DEVELOPMENT HEARING OFFICER
SUPPLEMENTAL SUBMITTAL

PROJECT NO. PR-2022-007299
Application No. SD-2024-00113

Re: Prelim / Final Plat Review for Proposed Subdivision of Tracts I-A and I-B, Coors Plaza, being comprised of Remaining Portions of Tracts I, Coors Plaza and Tracts 54 and 55, Unit 6, Town of Atrisco Grant

Plat for Tracts I-1 and I-2, Coors Plaza Being Comprised of Remaining Portions of Tract I, Coors Plaza, and Tracts 54 and 55, Unit 6, Town of Atrisco Grant City of Albuquerque, Bernalillo County, New Mexico May 2023

DRAWING NAME SITE DEVELOPMENT PLAN

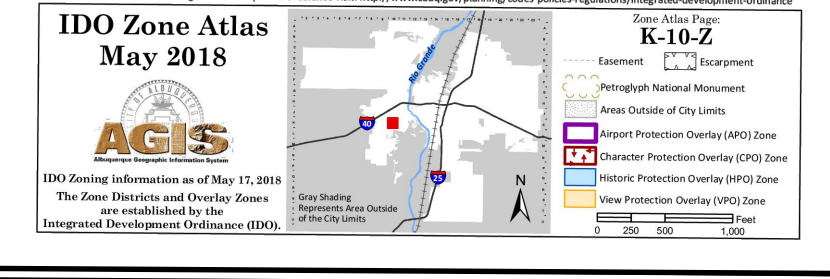
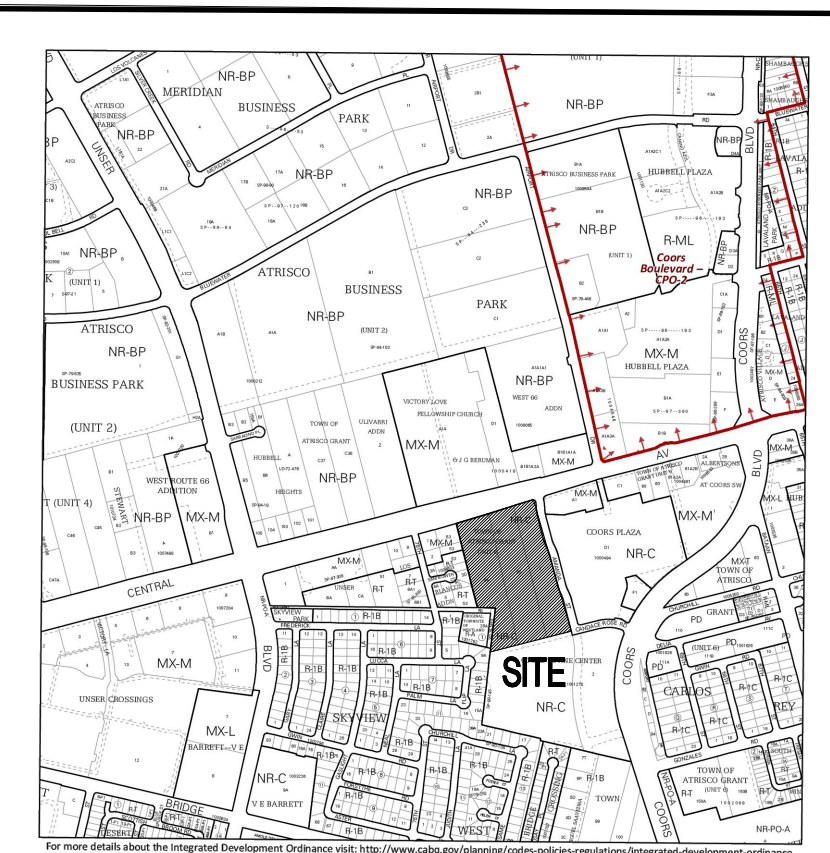
• Confirm if the site setback standards will be met for the proposed office/warehouse facility depicted on the site plan, and that all intended buildings will be within the setback standards.

Noted, site plan application shows intended setback distances. Site plan drawing is provided with this application to confirm.
